ADDENDUM

ADDENDUM NO.: 03
PROJECT NAME: Sherman Park Branch Library – Repairs and Renovations
PROJECT NO.: 08325
CONTRACT NO.: C1630
DATE OF ISSUE: July 30, 2026

NOTICE OF CHANGES, MODIFICATIONS, OR CLARIFICATIONS TO CONTRACT DOCUMENTS

S1.02

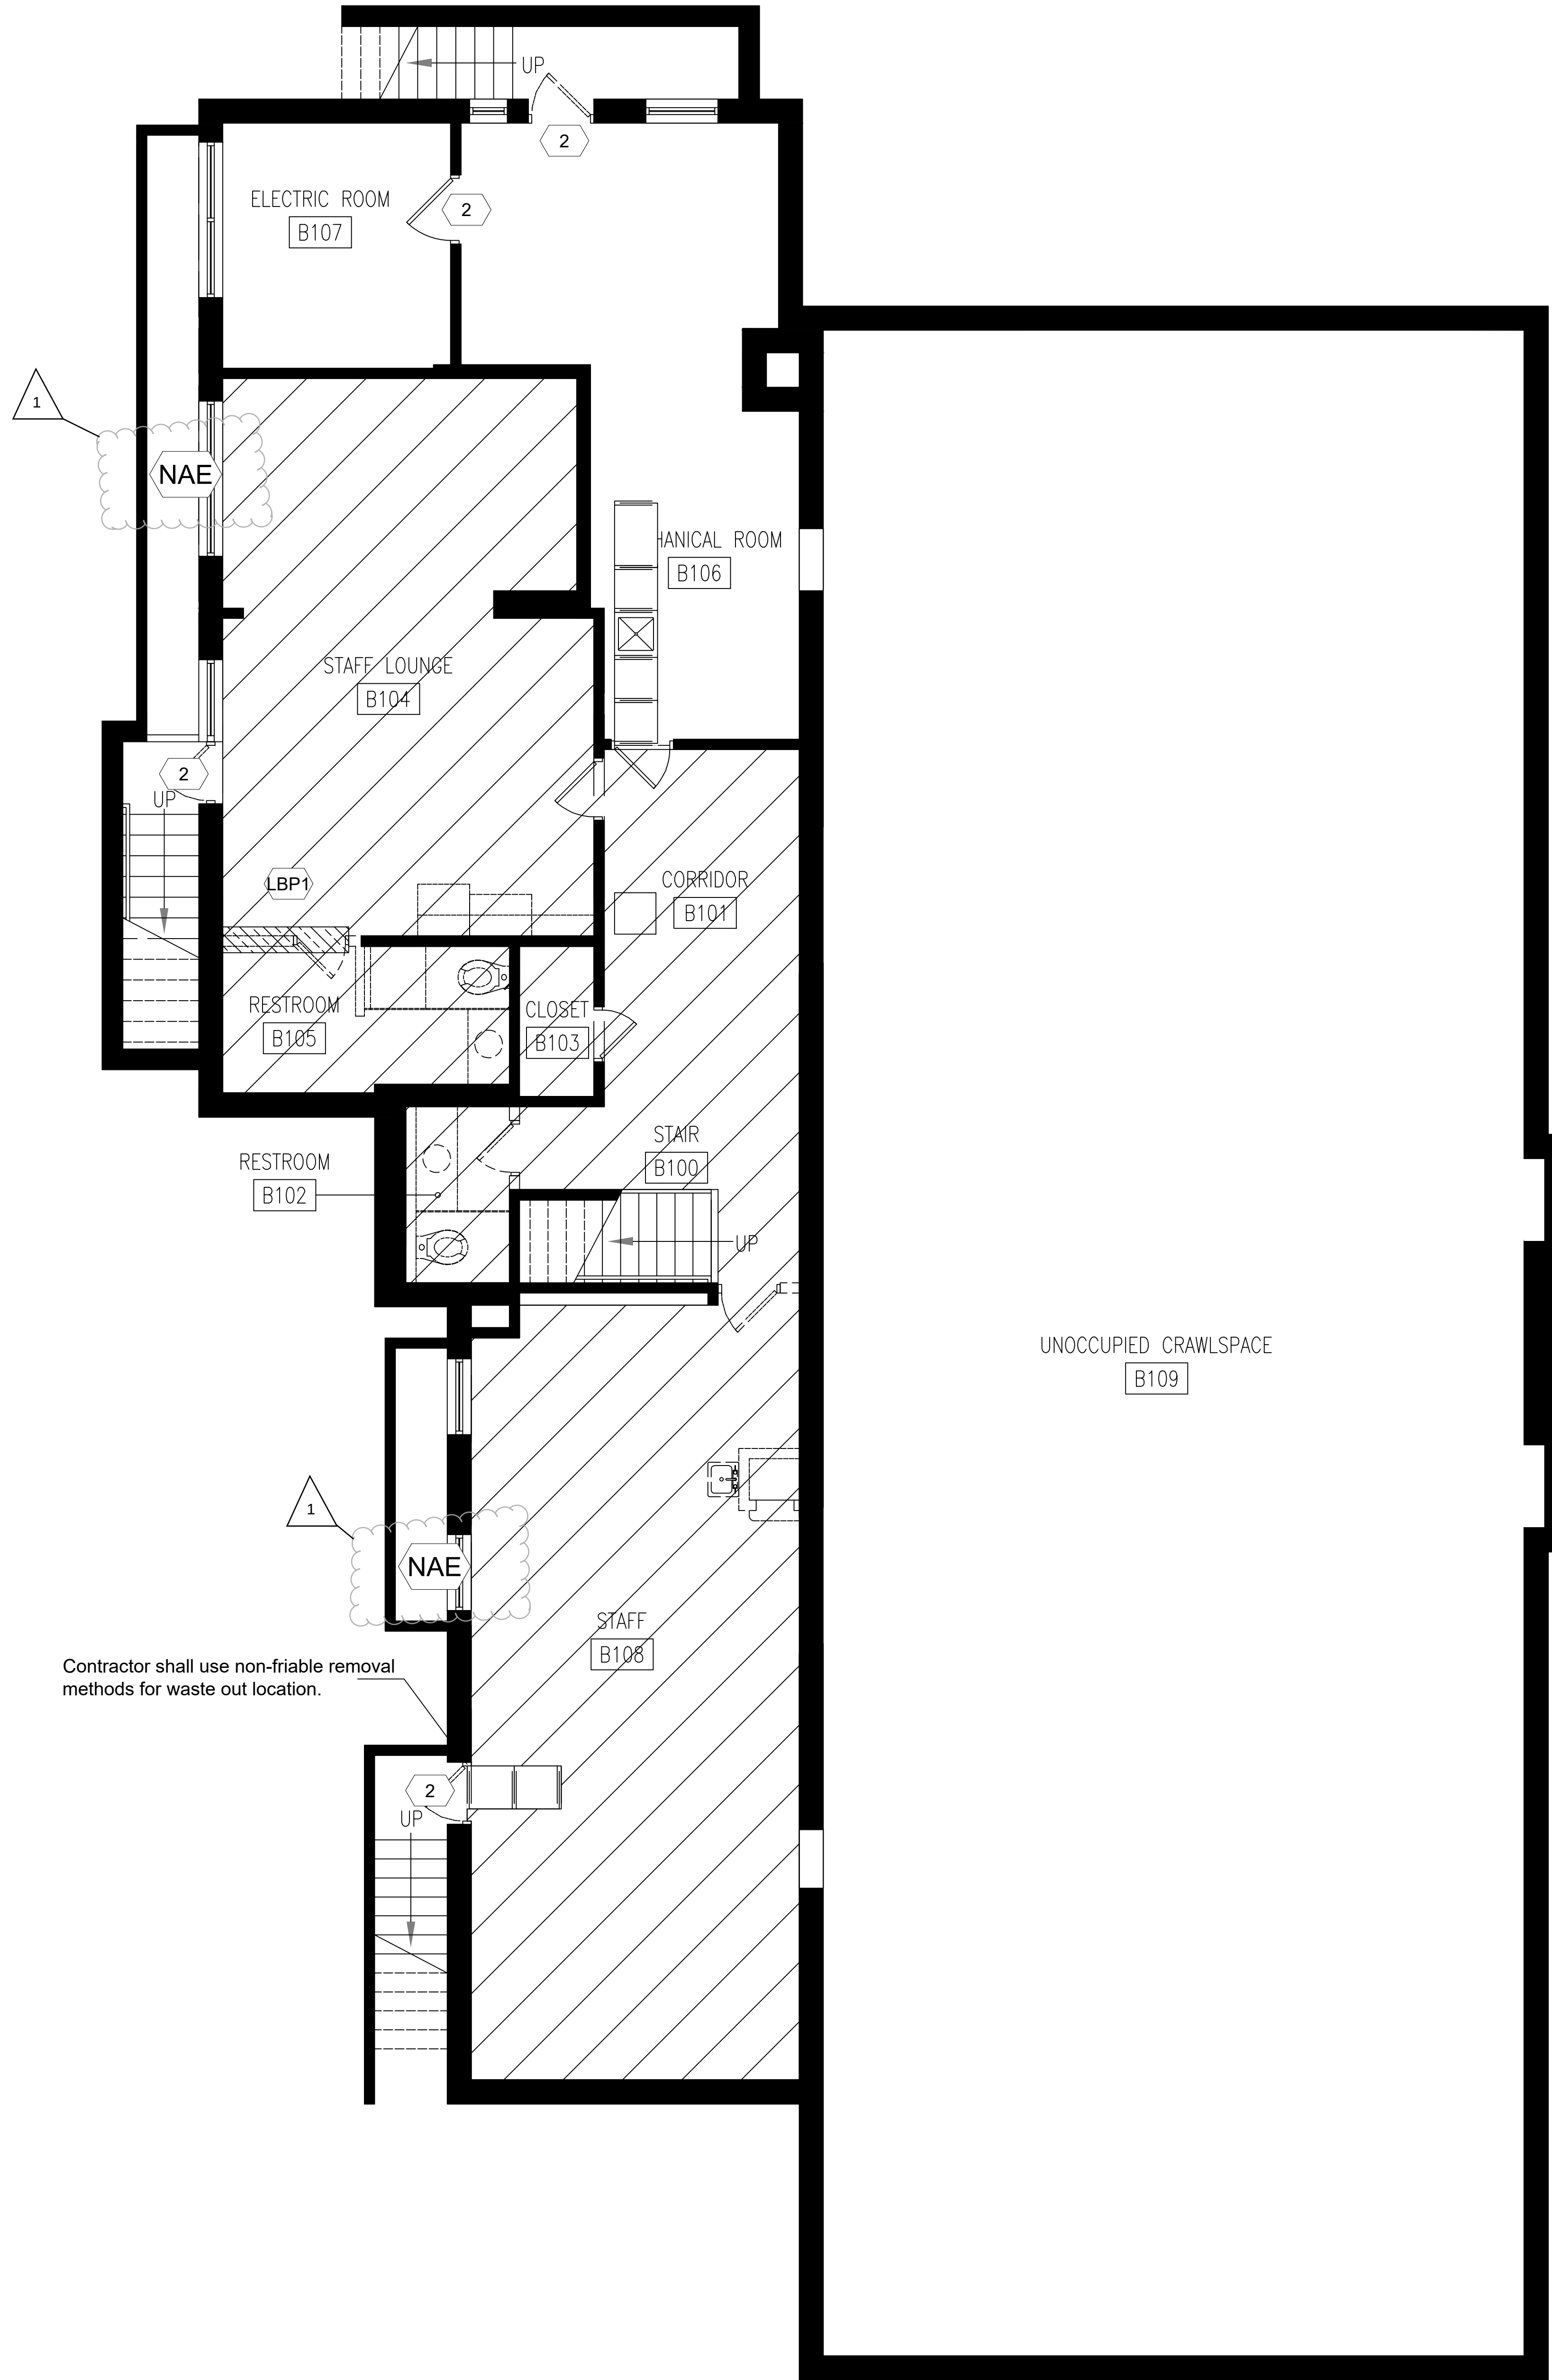
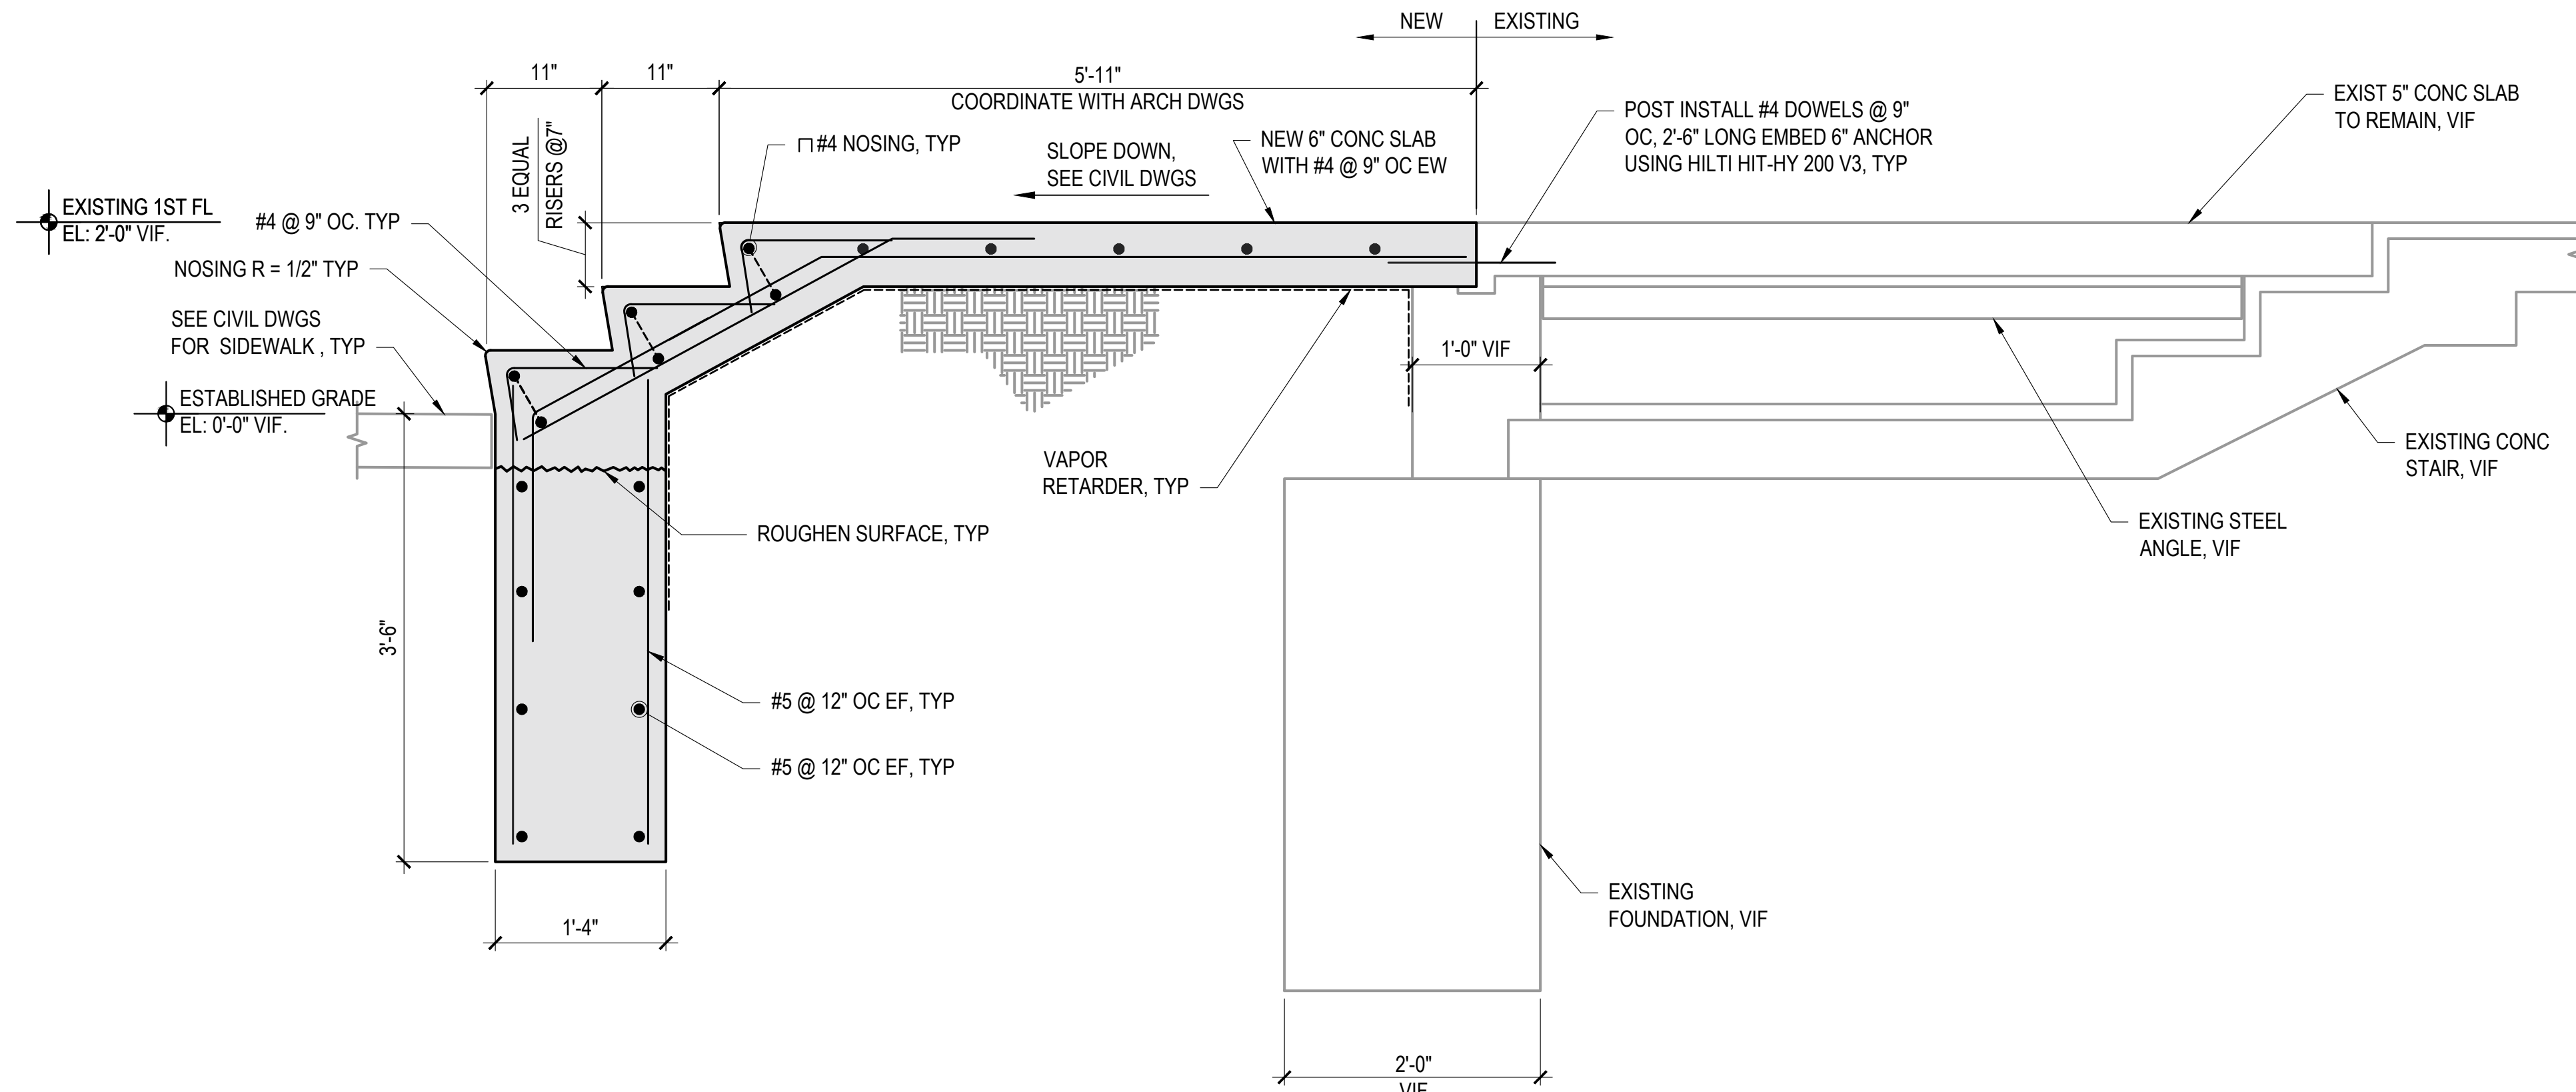
- Change 1** **REVISED** Sheet G.02: Identified Addendum No.3 Changes.
- Change 2** **REVISED** Sheet C0.00: Added planter detail 7/C0.00.
- Change 3** **REVISED** Sheet S1.02: Added planter note to Drawing 1/S1.02.
- Change 4** **REVISED** Sheet ENV1.0: Revised Abatement Plan Legend, unused keynotes have been removed. Location of Negative Air Exhaust (NAE) has been identified. Note No.8 replaces CPS with Owner. Separation/construction barrier and associated keynote have been modified in plan for clarity.

Question: Planter Detail- S1.02 refers to Landscape drawing. Landscape drawing refers to Architectural drawing. Architectural drawings refers to Civil drawing. Please provide detail of PLANTER.

Response: Please refer to revised drawings C0.00 and S1.02 included in this addendum.

ENV1.0

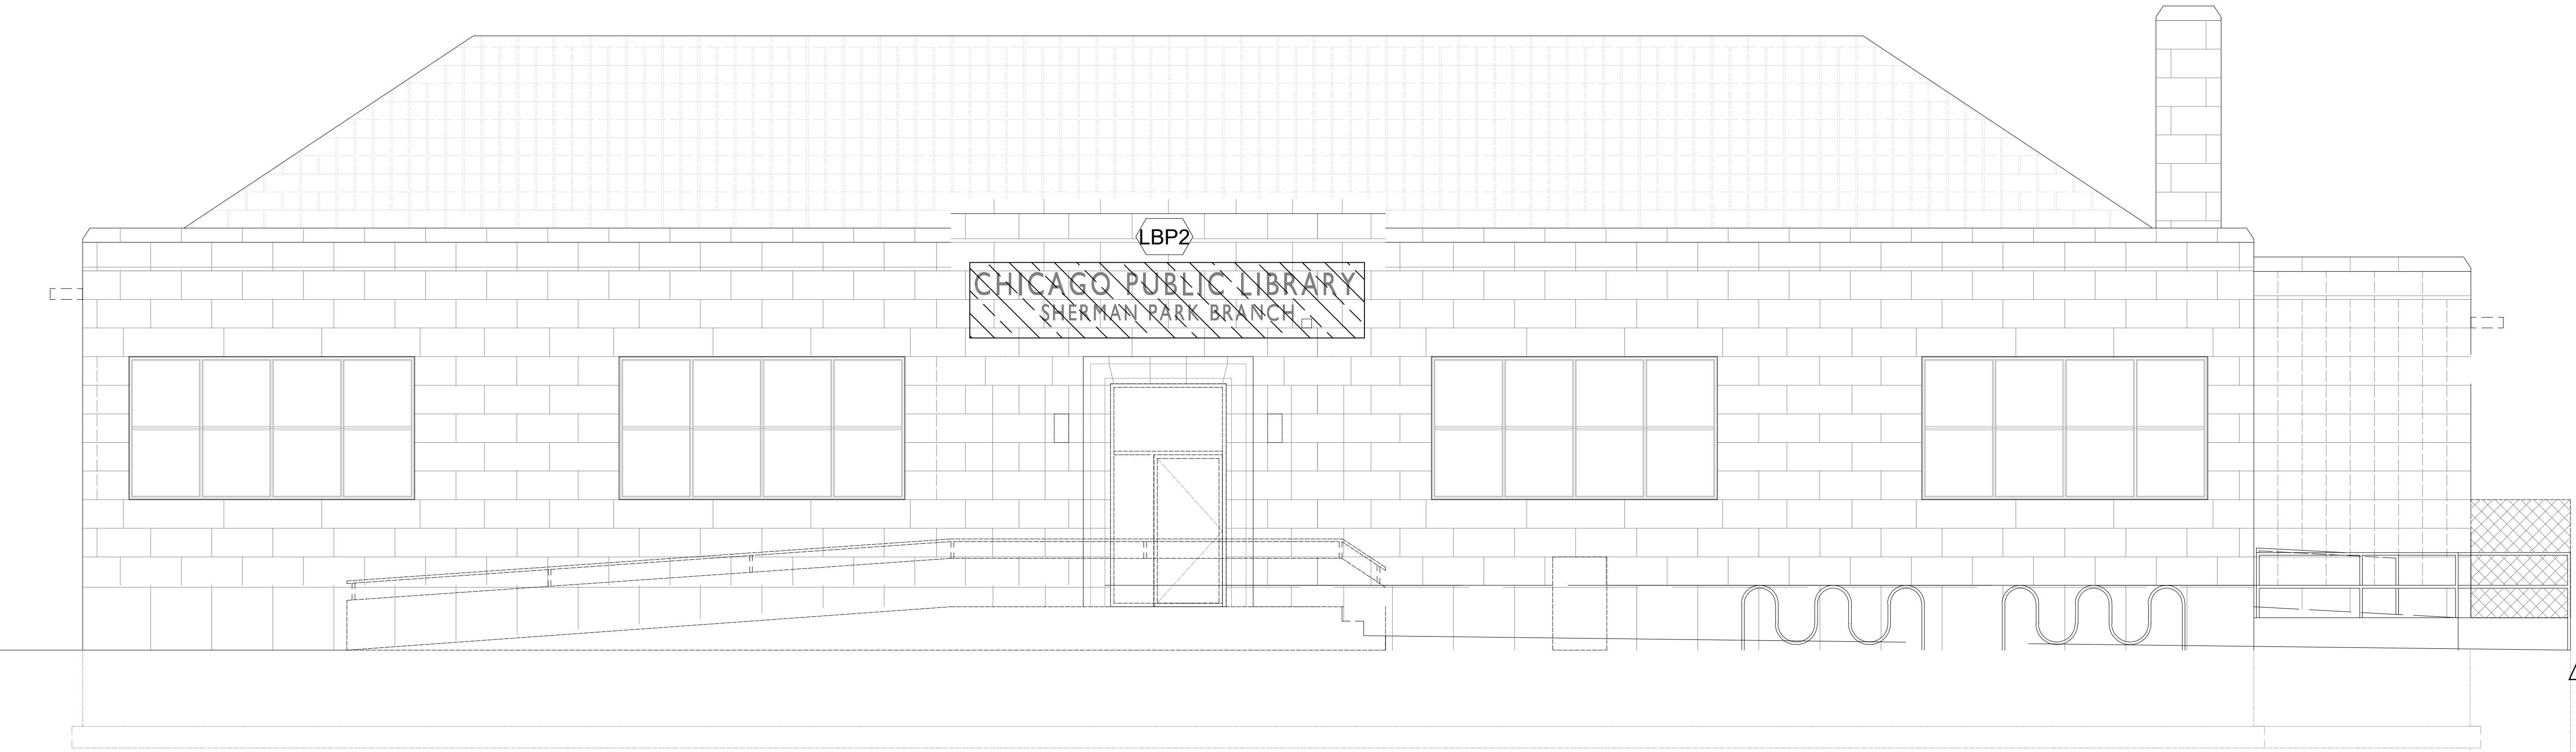
Response: Please refer to revised drawings ENV 1.0 and Env 1.1 included in this addendum. The NAE locations have been added to plan.

Question: Containment Area - no removal - not marked in plan. Please clarify.

- Change 5** **REVISED** Sheet ENV 1.1: Revised Abatement Plan Legend, unused keynotes have been removed. Location of negative air exhaust has been identified. Note No.8 replaces CPS with Owner. Separation/construction barrier and associated keynote have been modified in plan for clarity.
- Change 6** **REVISED** Sheet ENV 1.2: Revised Abatement Plan Legend, unused keynotes have been removed. Note No.8 replaces CPS with Owner.
- Change 7** **REVISED** Sheet ENV 1.3: Revised Abatement Plan Legend, unused keynotes have been removed. Note No.8 replaces CPS with Owner.

Response: Please refer to revised drawings ENV 1.0 and Env 1.1, included in this addendum. Containment Area - No Removal' area not used in plan. Unused keynotes have been removed for clarity.
